## NOTICE OF PLANNING DIRECTOR DECISION

Case File No.: HDP 10-98

Case File No.: SEC 33-98

**CORNELIUS PASS RD  
AT SHELTERED NOOK RD.  
CULVERT REPLACEMENT/SOULDER REPAIR**  
Designed ABC Drafted BCJ Checked SHT  
Date 3/09/98 Scale 1:250

**CORNELIUS PASS RD**  
 AT SHELTERED NOOK RD.  
 CULVERT REPLACEMENT/SOULDER REPAIR

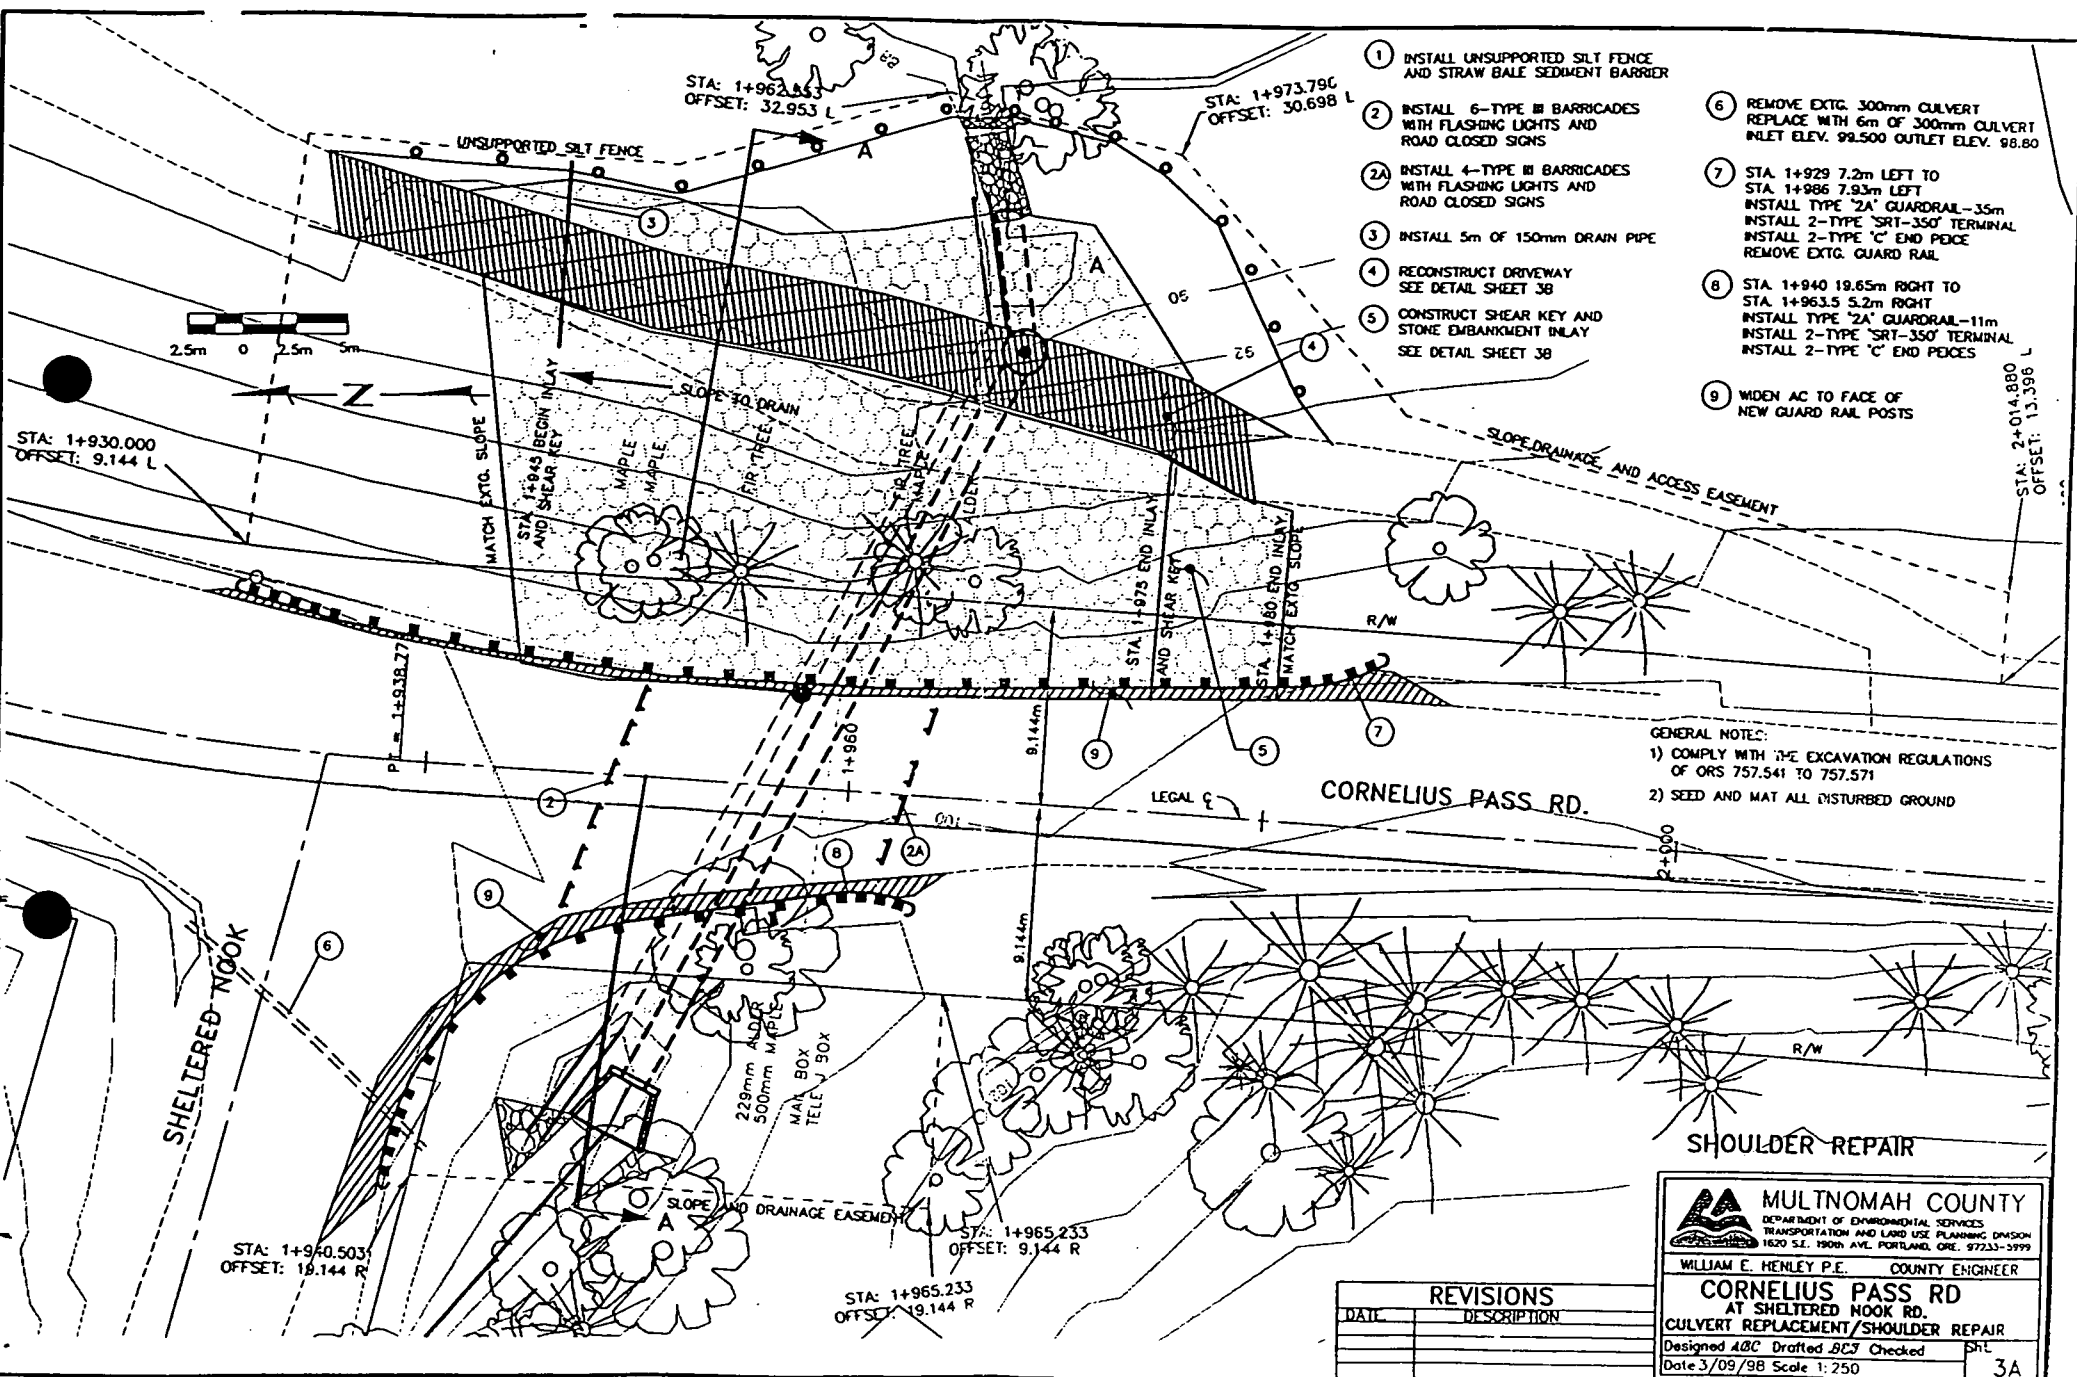
**Findings:** The slide area was filled with a mechanically compacted stone embankment, and areas that support structures (the road bed and culvert) were excavated to rock. A cross-section of reconstructed side slope areas is included on Sheet 3B of the County Engineer's plan.

**Findings:** The slope has been constructed at 1.5 to 1. The erosion control measures consisted of seeding with grass and installation of erosion control mesh blanket. The slope angles are shown on the plans produced by the County Engineer.

Staff notes that Cornelius Pass Road is within approximately 90' of McCarthy Creek, and the culvert replacement occurs within a tributary stream. Existing vegetation which was removed as shown on the site plan includes an Alder and Maple tree on the west side of the road, and an Alder, two Fir, and three Maple trees on the east (McCarthy Creek) side of the road. In addition, the Permit of Entry indicates 30 fir trees were to be removed and replaced as part of the project. On the 11/13/98 site inspection, staff noted no replanted trees in the area west of the road. A group of seven cedar tree seedlings are near McCarthy Creek on the east side of the road, and six did not survive.

2. The applicant shall re-apply grass seed to the project areas which are covered with mesh as soon as practicable in order to establish a stand of grass which is thick enough to reduce erosion of embankment areas.

3. The applicant shall replant the six Cedar trees along the riparian area of McCarthy Creek which did not survive after completion of the project. The replanting shall occur during the winter of 1998-99.

4. The applicant shall plant Douglas fir trees, or other tree suitable for the re-constructed road embankment, on approximately 10' on-center in order to replace and supplement trees removed during the project, and to inhibit re-establishment of Himalayan blackberry in the project area. This planting should occur during the winter of 1998-99, but must occur no later than the winter of 1999-2000. As an additional nuisance plant control measure, the applicant shall perform a minimum of two blackberry control applications spaced in different years.
